Work Order ID 165190-1

Item Name: Channel

APICAL INDUSTRIES, INC.	ENGINEERING CHANGE NOTICE NO. 03698				SHEET 1 OF 1	
	DWG NO. 647.0300	REV: N/C	PREPARED BY B. PETERS	DATE: 11/14/12	EFFECT ON DWG ☐ INC. ☒ UNINC.	
	DWG TITLE: CHANNEL					
APPROVED BY: ENGR <i>[Signature]</i>		MFG <i>[Signature]</i>	QC <i>[Signature]</i>	EFF: NEXT ORDER		
TRANSACTION CODES (TC): A-ADD C-CREATE R-REVISE D-DELETE	REASON: ADDED ALTERNATE MATERIAL.				ECR: D-12-016

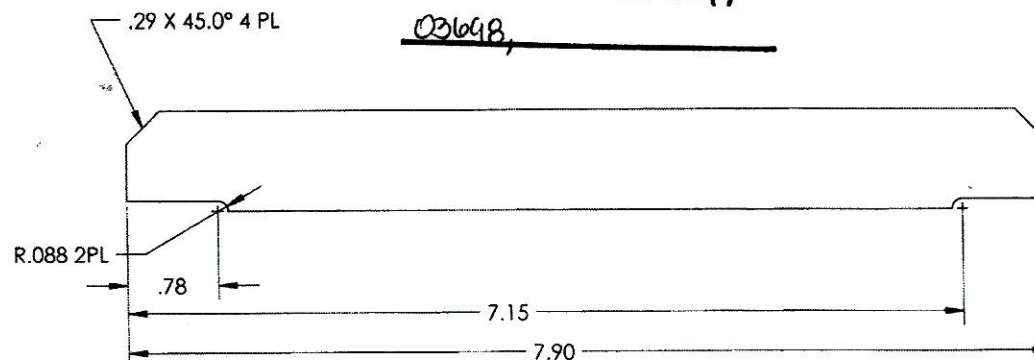
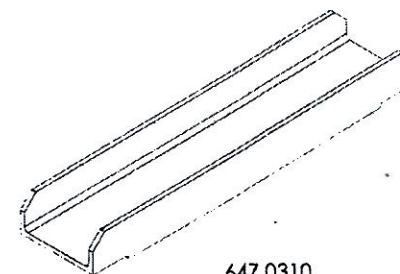
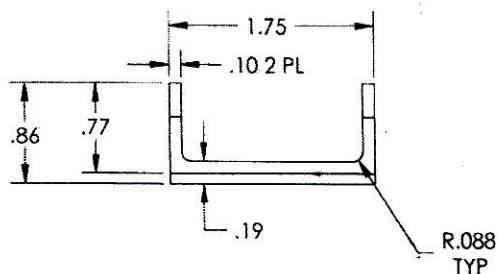
SHEET 1, ZONE A2 IS:

1 MATERIAL: 7075-T6 ALUMINUM PER AMS-QQ-A-225/9
ALTERNATE: 7075-T6511 ALUMINUM PER AMS-QQ-200/11
